Date: 09/17/15

# Wheaton Woods Elementary School Modernization, Preliminary Forest Conservation Plan No. MR2016001

Figure 2: Variance Tree Location

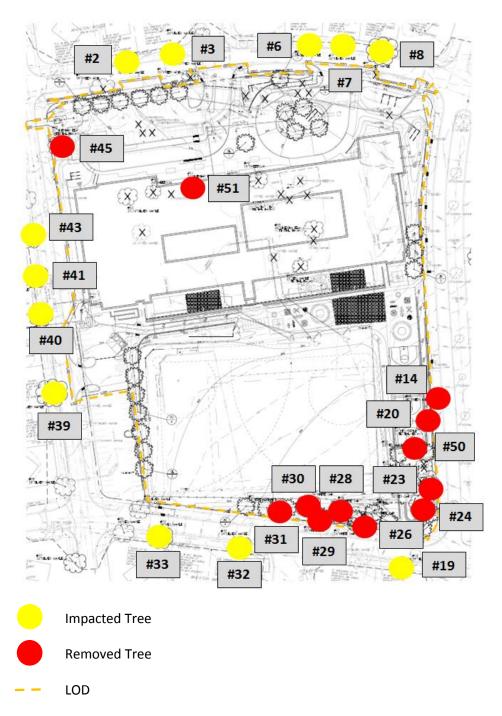
Two trees proposed for removal on the site, #45 and #51, both 31" diameter at breast height (DBH) Siberian elms, will be impacted by the demolition of the existing school and the addition of a new parking area. The installation of new outdoor play areas and a stormwater management outfall will require the removal of five trees: #14, 30" DBH green ash; #20, 35" DBH red maple; #23, 32" DBH red oak; #24, 40" DBH yellow poplar; and #50, 33" DBH red maple. Five trees proposed for removal will be affected by the grading of the athletic field: #26, 31" DBH white oak; #28, 30" DBH white oak; #29, 30" DBH white oak; #30, 34" white oak; and #31, 33"DBH mockernut hickory.

Leaving the requested trees in an undisturbed state would result in an unwarranted hardship because the Applicant would not be able to remove any existing features or install any new features or stormwater management facilities.

The Applicant is requesting a variance to remove twelve trees. The twelve trees (listed in the removal table on page 5) are outside of a forest and will be mitigated at a rate of 1" caliper per 4" DBH removed, using a minimum 3" caliper native shade tree. The Applicant will plant thirty-three, 3-inch caliper trees on the property, which will be shown on the Final Forest Conservation Plan.

<u>Variance Recommendation</u> - Staff recommends that the variance be granted.
